Information No: 840412

Product: TPT 3011

Front End modification

Service Information

FRONT-END

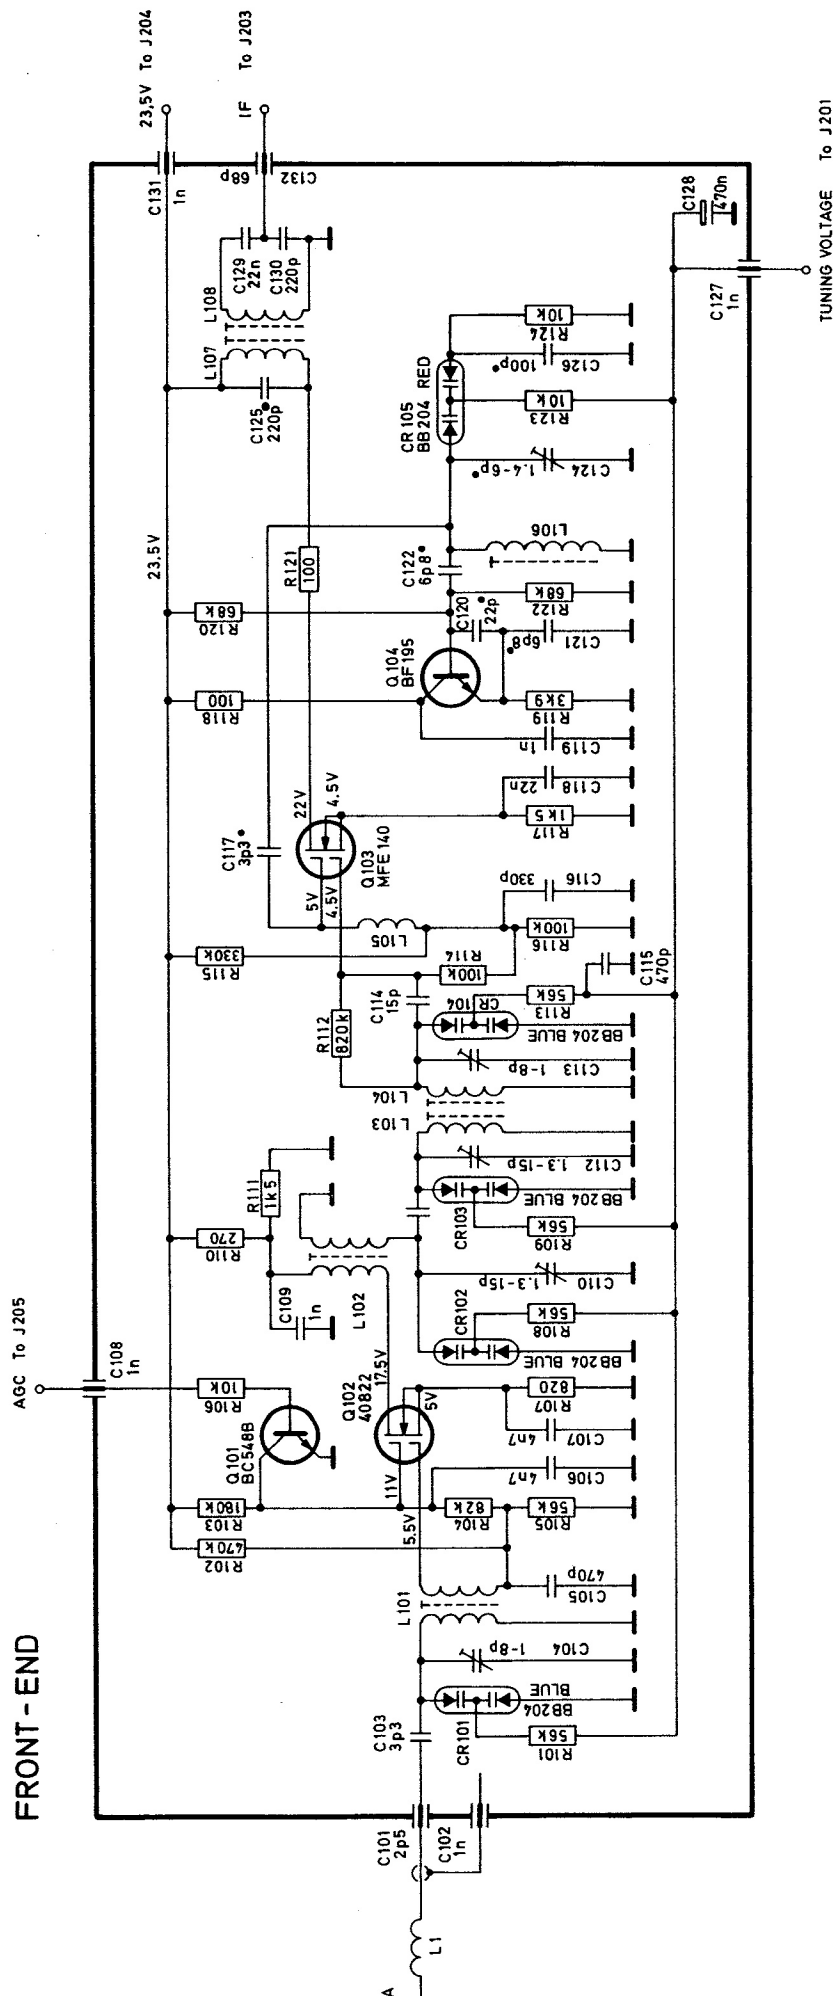
From serial No. 1700 an adjustment of L106 is introduced. The part No. on the new L106 is 401141. At the same time C117 is changed to 3.3 pF NPO and C123 is left out.

Turn the tuning knob to the lowest frequency (end position) on the dial.

- Adjust R202 to 3 V measured on J201.
- Turn the tuning knob until you read 4 V on the voltmeter, set the pointer to the 90 MHz mark on the dial and seal the pointer.
- Adjust L106 to 90 MHz at the 90 MHz mark*.
- Turn the tuning knob to the 105 MHz mark on the dial.
- Adjust C124 to 105 MHz on the oscilloscope*.

- C117 NPO
- C120 NPO
- C121 N750
- C122 N750
- C125 NPO
- C126 100 p N1500
- C124 p.No. 263501
- 3.3 p NPO
- 22 p NPO
- 6.8 p N750
- 6.8 p N750
- 220 p NPO
- 100 p N1500

Selectivity board, component side

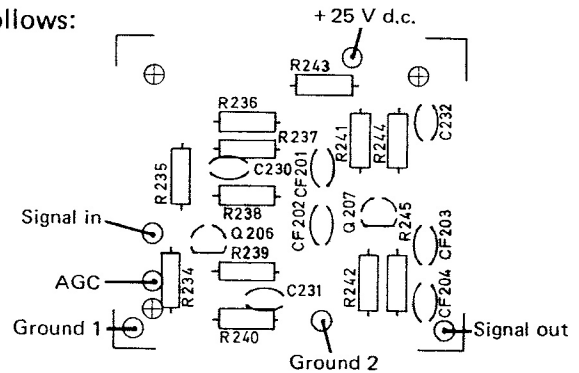
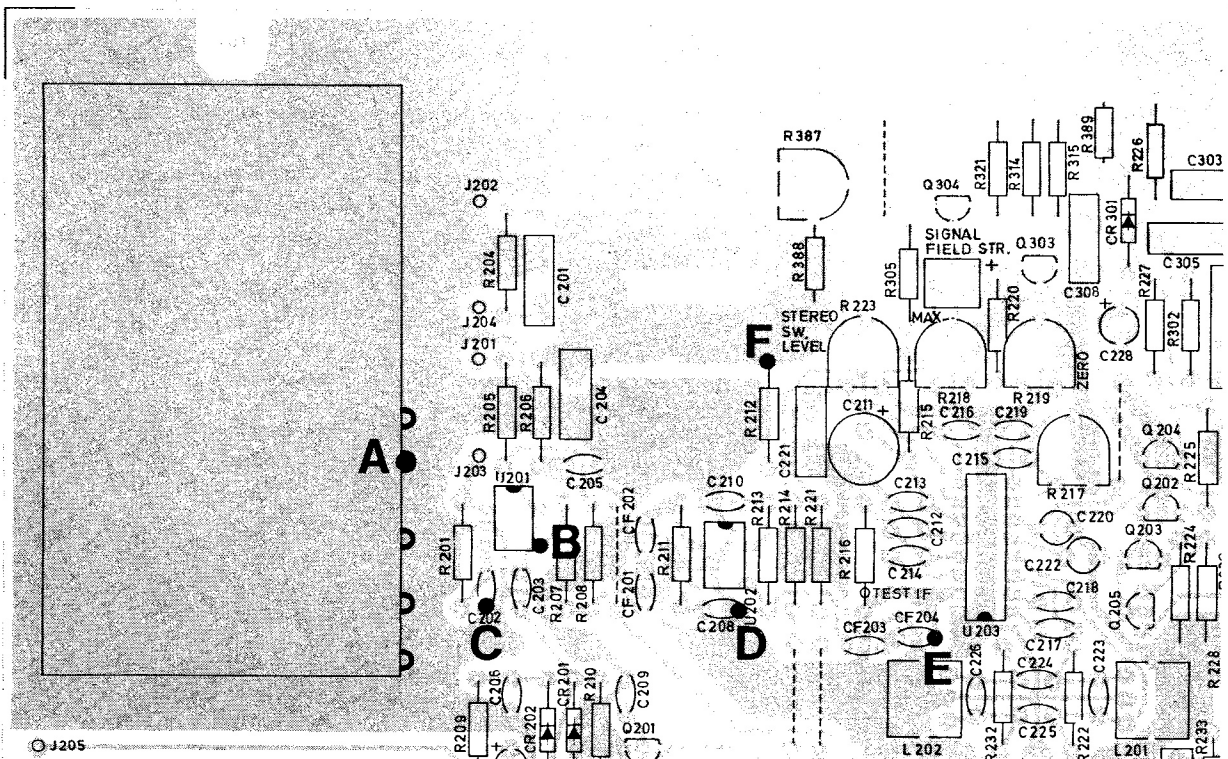
The IC-circuits UA 703 HC and HA 1201 are no longer available from our Spares Department. Those circuits are replaced by a new p.c. board (Selectivity board), part No. 997007.

Before replacing UA 703 HC or HA 1201 with the Selectivity board, remove the following components on the main board:

U 201	R 201	R 211	C 202	CF 201
U 202	R 206	R 212	C 205	CF 202
	R 207	R 213	C 208	CF 203
	R 208		C 210	CF 204

When replacing the IC-circuits the procedure is as follows:

Selectivity board	Main board
Connect:	to the point marked:
Signal in	A
AGC	B
Ground 1	C
Ground 2	D
Signal out	E
+ 25 V d.c.	F

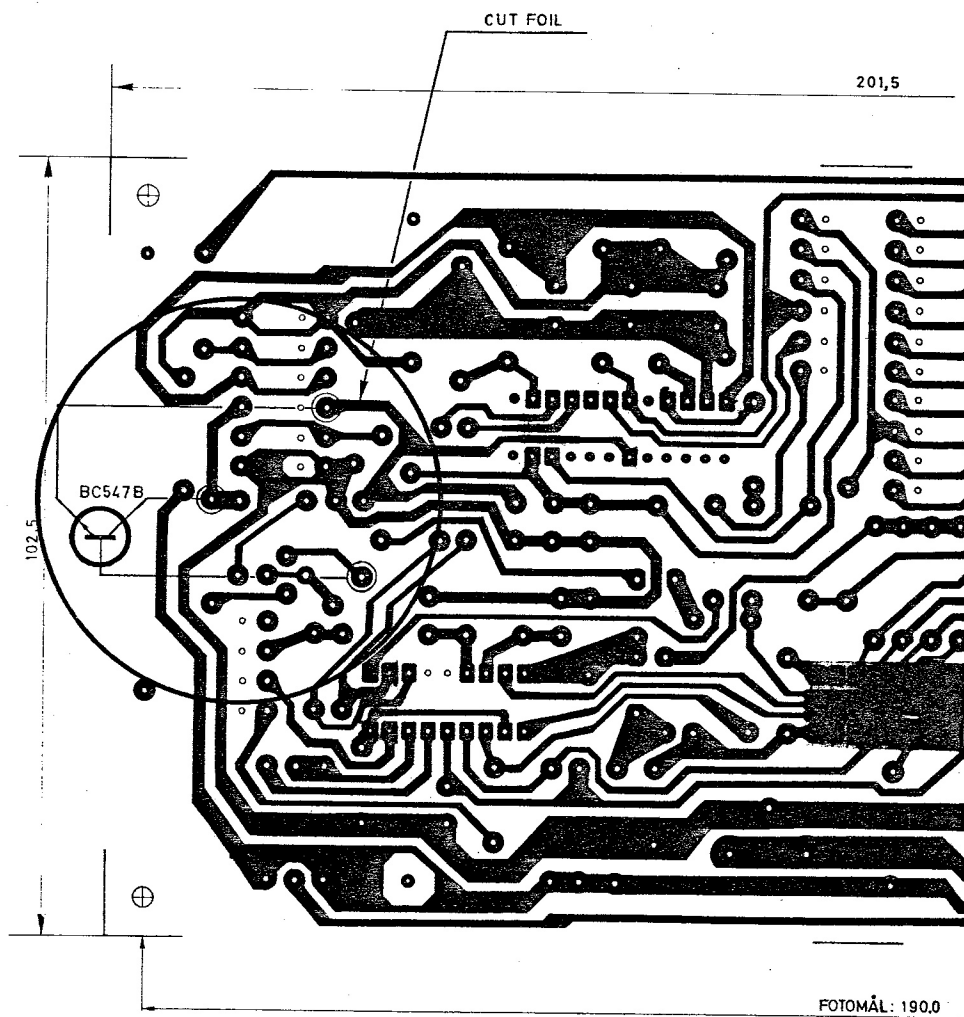
Introduced from serial No.	Symptom	Modification
350	Drifting	Front end: Change C125 to a capacitor with temp. coeff. NPO. Selectivity: Change C223 and C226 to a capacitor with temp. coeff. NPO.
400	Increased sensitivity for switching from Pre-set to manual tuning (Tuning sense circuit).	Main board, remove the following components: R344, R345, R346, R347, R348, R349, R350, R351, R352, U302, C329, C330, C331, C332, C333, C334, C335, CR306, CR307, CR309 and CR310. Connect a 16 pins IC-socket instead of U302 and plug in a new PC-board, part No. 997005 faced to the front end box (turned away from the fly-wheel). Solder the wire on the PC-board to the flat spring close to the fly-wheel.
590	Overheat control of U1002	Tuning system 2: Install separate current generator for U906 (tun. syst. 1), consisting of one transistor, BC547B coupled according to diagram, and change the value of R1037 to 270 ohm. Cut the PCB foil near the emitter connection of BC547B as shown in the PCB drawing.

CHANGE TO NEW IC-CIRCUIT

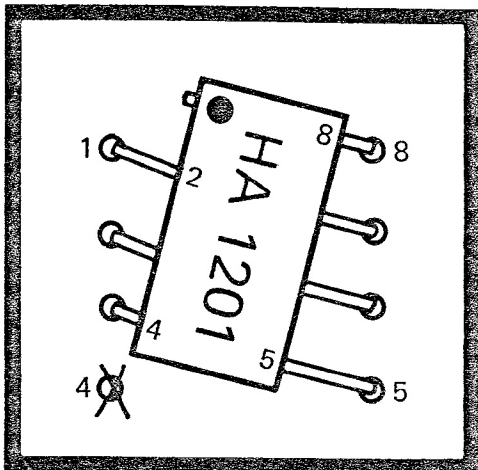
Circuit UA703HC is no longer available from our Spare Parts Department.
This IC-circuit is replaced by HA1201, part No. 417824, (U201 and U202).

When you must replace UA703HC with HA1201, the following change must be done:

Cut off leg No. 1 on the IC-circuit.

Put the legs No. 5-8 into the holes 5-8.

Then turn the circuit slightly (see figure) so that hole No. 4 in the PC-board is not used and enter the three legs No. 2-4 as shown in the figure.

Touch sense board, component side

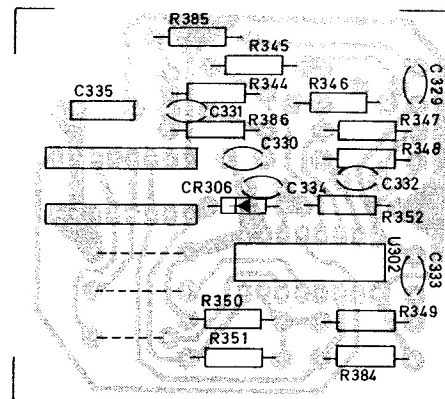
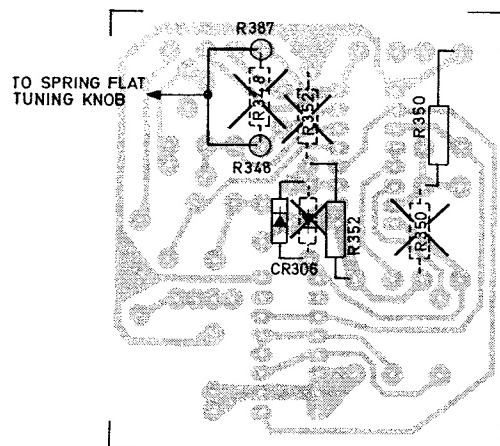
In addition to the previous modification we will also recommend you to do the following modification on the tuning sense board as shown in the figure. This modification makes the receiver less sensitive for external radiation fields.

- CR306 is turned in opposite direction
- R350 and R352 are connected as shown in the figure
- R348 is replaced with 2 pcs. of 330 kohms and a wire is soldered to the center of the two 330 kohms.

The other end of the wire is connected to the flat spring behind the flywheel on the tuning knob.

Part of main board, component side

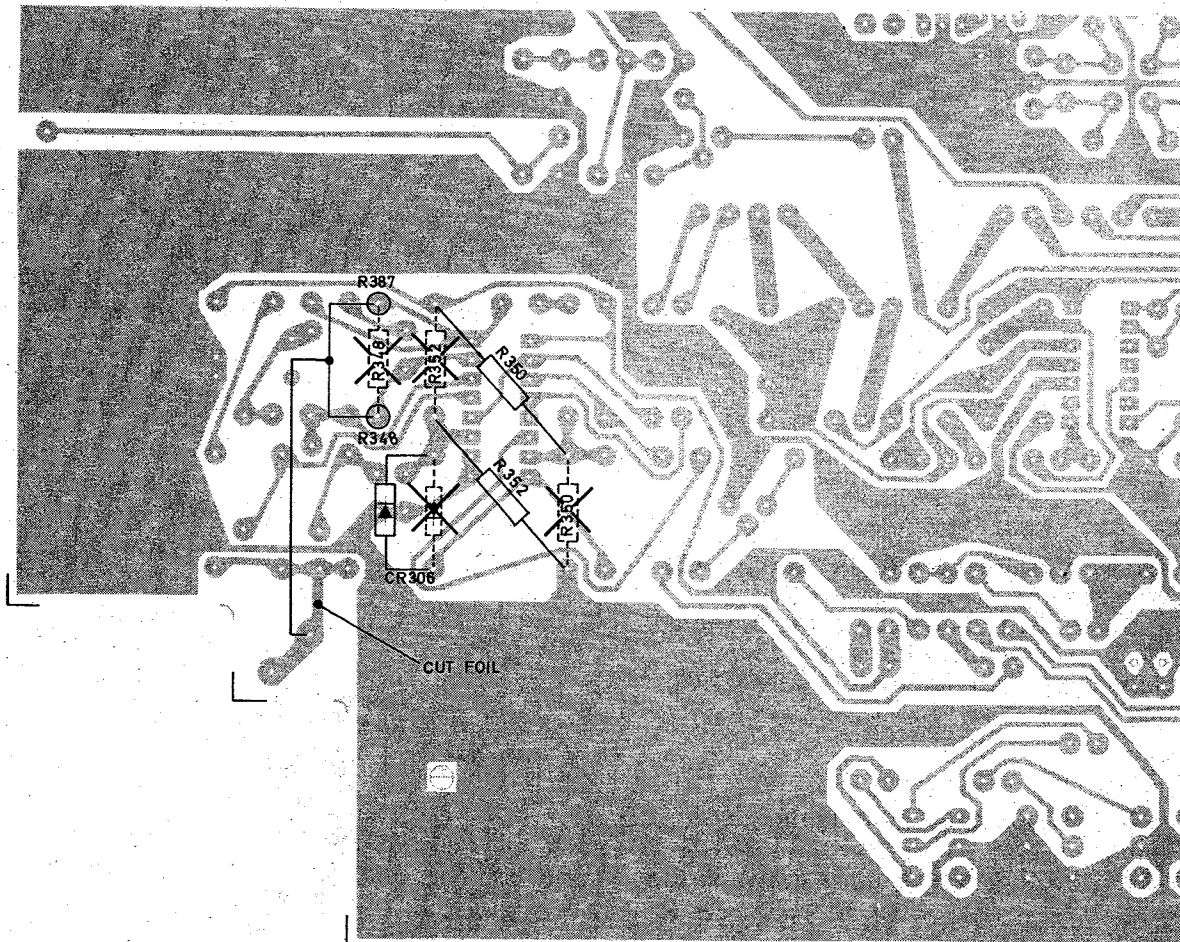
2. This modification also makes the receiver less sensitive for external radiation fields.

On receivers with serial No. from 0400 to 1600 following modifications should be carried out:

- CR306 is turned in opposite direction
- R386, change the value to 47 kohm
- R344, change the value to 1 Mohm
- R345, change the value to 1 Mohm
- R346, change the value to 820 kohm
- R347, change the value to 680 kohm
- R349, change the value to 330 kohm
- R348 is replaced with 2 pcs. of 330 kohms and a wire is soldered to the center of the two 330 kohms. The other end of the wire is connected to the flat spring behind the flywheel on the tuning knob and the foil is cut as shown in the figure.

Main circuit diagram TPT 3011

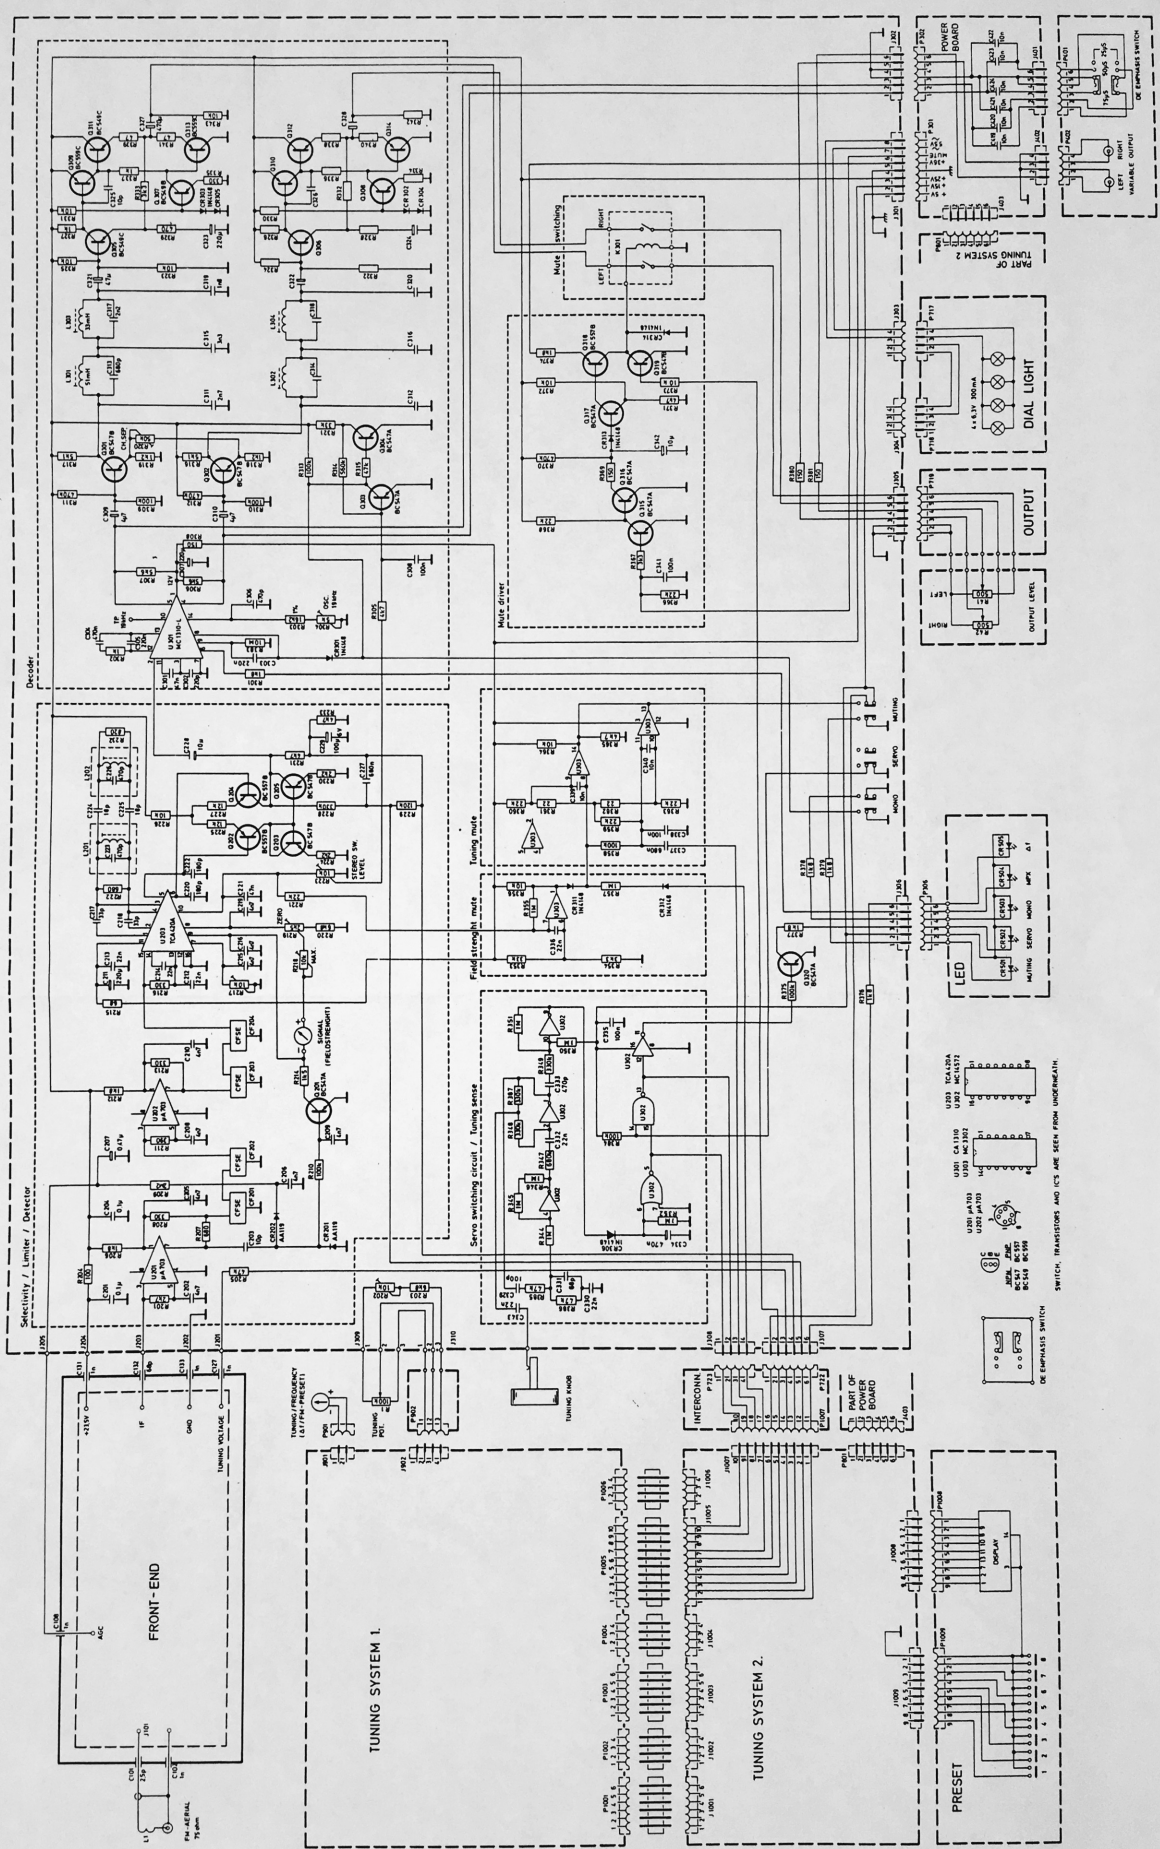
38 kHz adjustment

Due to variation in the 38 kHz trap in U 301 – MC 1310L an adjustment is introduced from serial No. 2050.

Apply a 500 μ V unmodulated stereo signal and measure on the output with a selective – or a wide band voltmeter and adjust R 387 to minimum reading.
